# ATTACHMENT A: Project Modification Request (PMR) Form

Regional Program	<ul> <li>➢Infrastructure Program Project</li> <li>□ Scientific Studies Program</li> <li>□ Technical Resources Program</li> </ul>
Project/Study Name	Fulton Playfield Multi-Benefit Infiltration Project
Project/Study Lead	City of Redondo Beach
Watershed Area(s)	South Santa Monica Bay
Current Project Phase	Design
Approved Stormwater Investment Plan Fiscal Year	FY22-23
Transfer Agreement ID (e.g., 2020RPULAR52)	2022RPSMB02

#### Subject: Attachment B – Project Modification Supplementary Documentation

On October 31<sup>st</sup>, 2024, the City of Redondo Beach ("Redondo Beach") submitted a Project Modification Form (PMR) for the Fulton Playfield Multi-Benefit Infiltration Project ("Project"), which was originally approved during Round 3 of the Safe Clean Water Program Stormwater Investment Program (SCWP SIP). This letter provides supplementary documentation to the PMR.

Figure 5 - Proposed Modifications for Downtown Lomita Multi-Benefit Stormwater Project Design

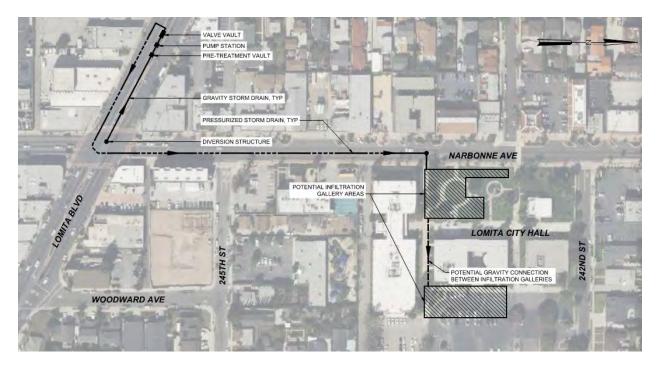
A conceptual design for the proposed City Hall infiltration gallery was developed, shown in Figure 5, that includes a single diversion to capture the entire Project drainage area, and incorporates a submersible pump station on Lomita Boulevard to convey stormwater flows to an infiltration gallery. Due to the proximity of the proposed infiltration gallery to the previous geotechnical investigation, it is anticipated that infiltration rates will remain similar. However, if a geotechnical investigation reveals lower infiltration rates, there is enough space available for an infiltration gallery that is large enough to provide additional capacity for storage and infiltration.

The modifications to the Downtown Lomita Multi-Benefit Stormwater Project maintains the benefits identified in the SCWP application and feasibility study. The project continues to provide the same capture volume, tributary area, project location, and community benefits as the original project. The modifications to the subsurface features are required to accommodate geotechnical findings, but they do not ultimately change the intention of the project to capture, pretreat, and infiltrate stormwater from the tributary area for the 85<sup>th</sup> percentile 24-hour storm event, providing identical water quality benefits.
